87C196KT/87C196KS SPECIFICATION UPDATE

Release Date: January, 1997

Order Number: 272862-002

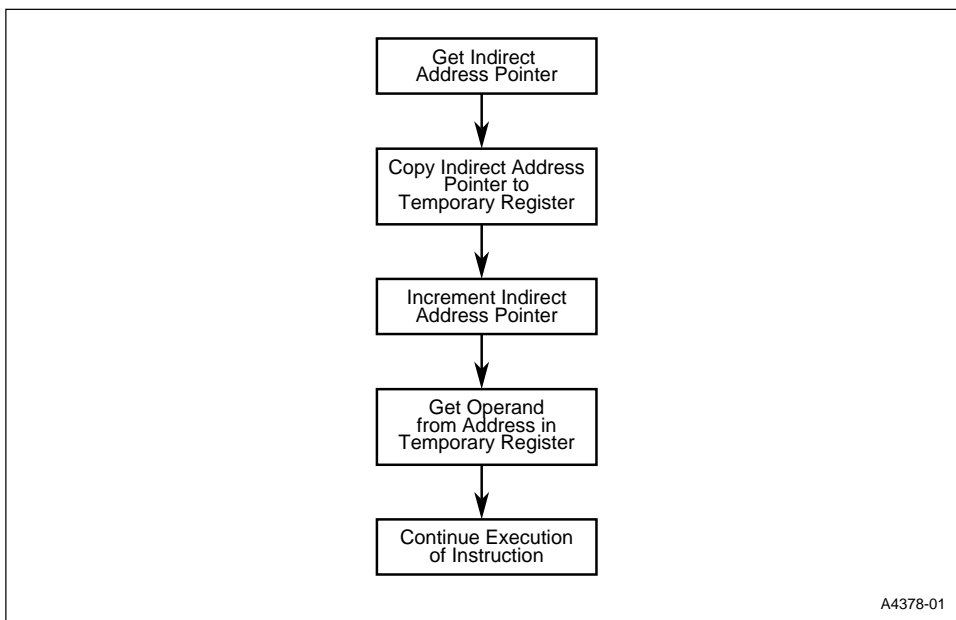
PROBLEM: The EPA can lock up if overruns are handled incorrectly. Overruns occur when an EPA input transitions at a rate that cannot be handled by the EPA interrupt service routine. If no overrun handling strategy is in place, and if the following three conditions exist, a situation may occur where both the capture buffer and the EPAX_TIME register contain data, and no EPA interrupt pending bit is set:

- an input signal with a frequency high enough to cause overruns is present on an enabled EPA pin, and
- the overwrite bit is set (EPAX_CON.0 = 1; old data is overwritten on overrun), and
- the EPAX_TIME register is read at the exact instant that the EPA recognizes the captured edge as valid.

The input frequency at which this occurs depends on the length of the interrupt service routine as well as other factors. Unless the interrupt service routine includes a check for overruns, this situation will remain the same until the device is reset or the EPAX_TIME register is read. The act of reading EPAX_TIME allows the buffered time value to be moved into EPAX_TIME. This clears the buffer and allows another event to be captured. Remember that the act of transferring the buffer contents to the EPAX_TIME register is what actually sets the EPAX interrupt pending bit and generates the interrupt.

WORKAROUND: Any one of the following methods can be used to prevent or recover from an EPA overrun situation.

- Clear EPAX_CON.0

When the overwrite bit (EPAX_CON.0) is zero and both the EPAX_TIME register and the capture buffer are full, the EPA does not consider a captured edge until the EPAX_TIME register is read and the data in the capture buffer is transferred to EPAX_TIME. This prevents overruns by ignoring new input capture events when both the capture buffer and EPAX_TIME contain valid capture times. The OVRx pending bit in EPA_PEND is set to indicate that an overrun occurred.

Figure 1. 16-bit System with EPROM

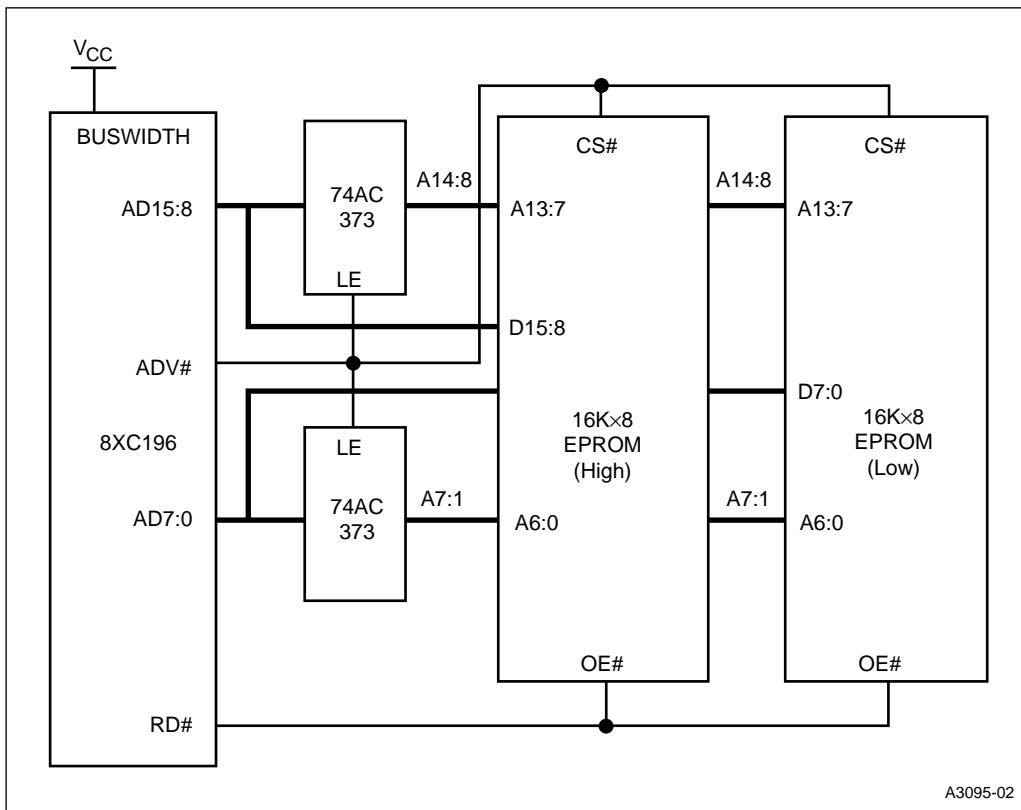
001. *High address inputs to the low EPROM should be A14:8 in Figure 15-18.*

ITEM: The next revision of the user's manual will include the following corrected graphic.
